From: Clelland, Steve
Sent: Friday, October 15, 2010 10:48 AM
To: 'Charles E. Brockway'
Cc: Fritschle, Carter; Clelland, Steve; Spencer, Nick
Subject: FW: Trail Creek Dam - IDWR
Attachments: Brockway Fig2.pdf; Brockway Fig1.pdf; Photo1.pdf; Photo2.pdf; Photo3.pdf

From: Falk, John
Sent: Thursday, October 14, 2010 6:03 PM
To: Clelland, Steve
Cc: Skinner, Corey; Galloway, Chuck; Hornbaker, Sonny
Subject: Trail Creek Dam

TRAIL CREEK DAM

IDWR FILE 37-12111

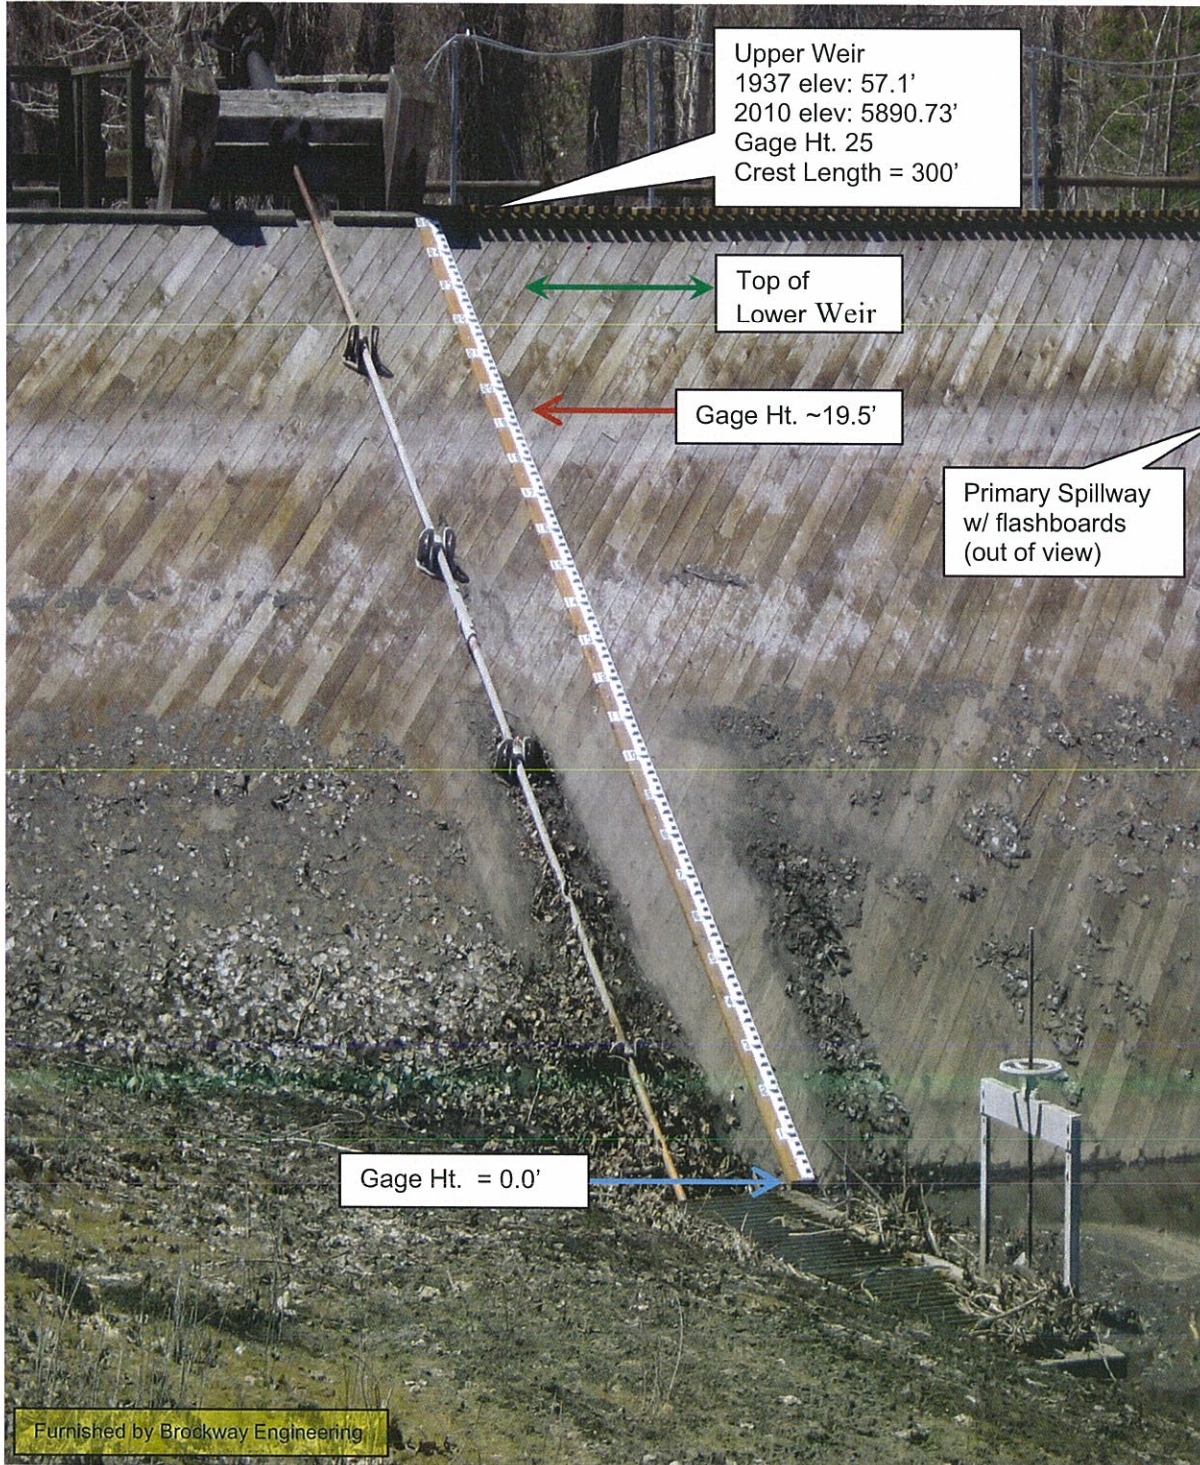
However, it is important to note that the dam is not operated with the pool at the crest of the Upper Weir...or even the Lower Weir for that matter. Instead, the pool level is held to an even lower elevation by means of adjusting the flashboards to maintain adequate freeboard. Photo No's 2 & 3 provide visual evidence that the normal operating reservoir surface has not exceeded Gage 19.5. Using photographs and Mr. Brockway's capacity table, the "historic normal" storage capacity of the reservoir evidently is 66.5 acre-feet, more or less; corresponding approximately to NAVD88 elevation 5887.9 feet (rounded to tenths).

- Authorization for a storage right equal to 66.5 acre-feet, plus an amount for evaporation/seepage.
- For dam safety reasons, static freeboard not less than 2.0 feet should be maintained between the crest of the Lower Weir and the normal operating pool level given the type of dam construction, its hazard classification, age, and the size of contributing watershed.
- From this point forward, all elevations should be reported using the most recent survey data; i.e. NAVD88.

Figure 1

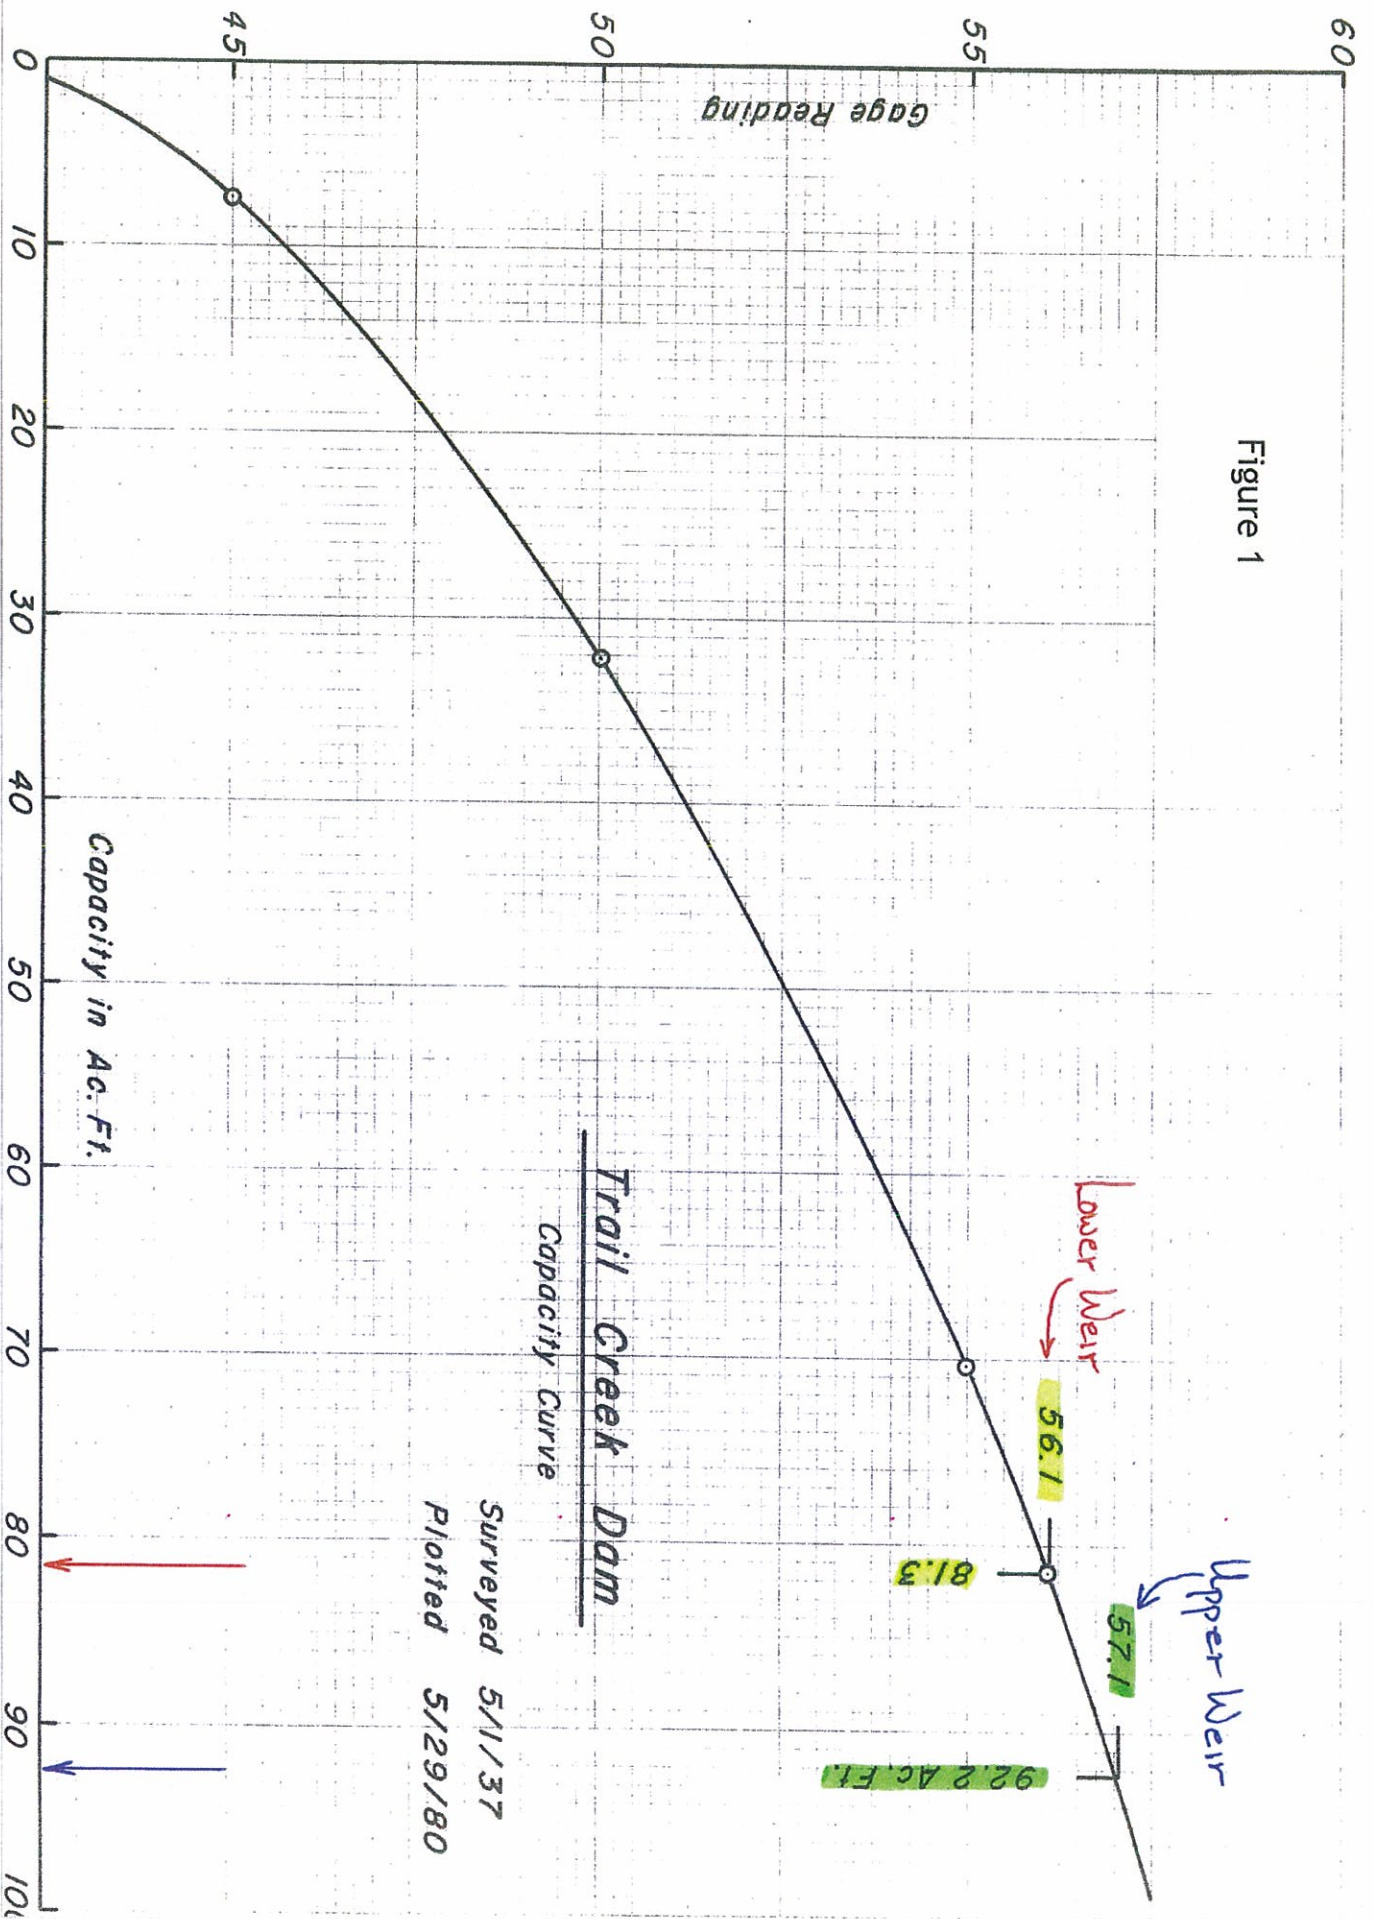
Of primary interest is the table (Figure 2) containing values for Staff Gage, NAVD88 Elevation, and Volume. Considering previous data (Figure 1), I have expanded Mr. Brockway's table to include the original 1937 design data that is coincident with the recent information. This correlation demands that the top of the Staff Gage has been set equal to the crest of the Upper Weir, and both features were surveyed to elevation 5890.73'.

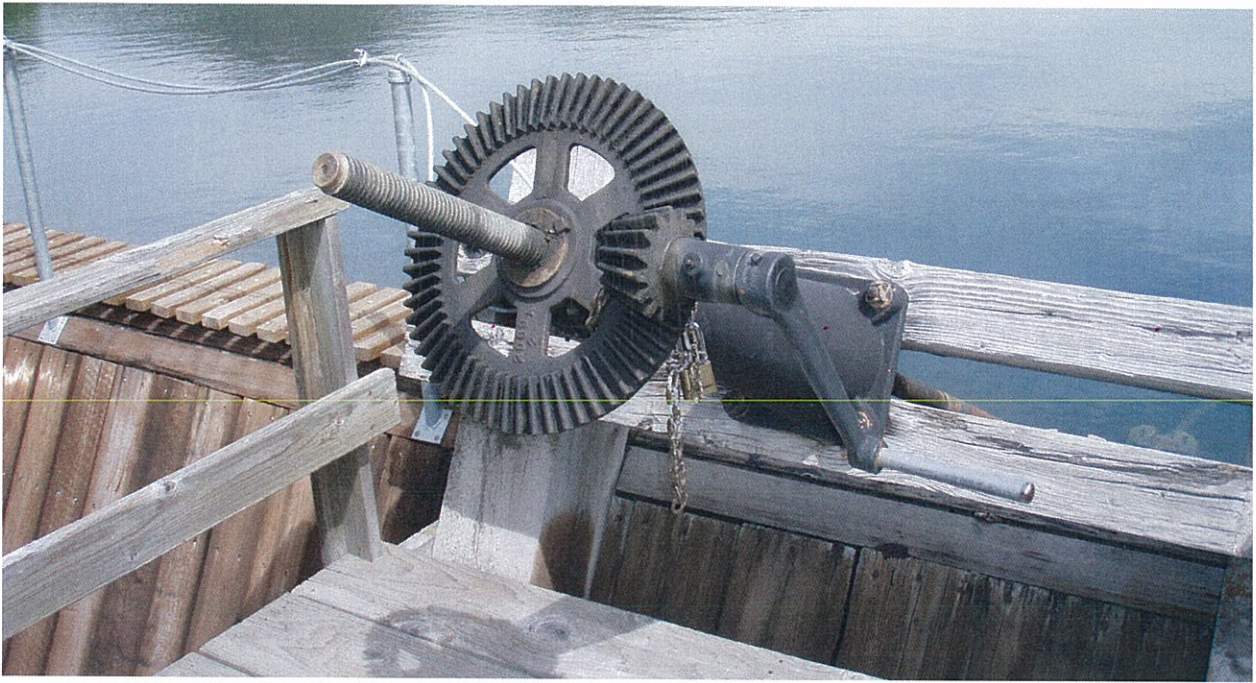
LEFT: View from atop low level outlet walk way looking down at two holes located along the toe of the dam to the left (southeast) of the low level outlet. The larger of these two holes is the hole that is visible in the view above. The exact cause of these two holes is unknown, but it is possible that they may be related to water inside the dam. The presence of these holes is not a structural threat to the dam, but their presence is unusual. The holes should be backfilled with granular material and the area monitored in the future.

- Remove woody vegetation (willows and trees) along toe of dam.
- Investigate and repair eroded areas as needed.
- Make efforts to reduce ponding of water along toe and inside dam.
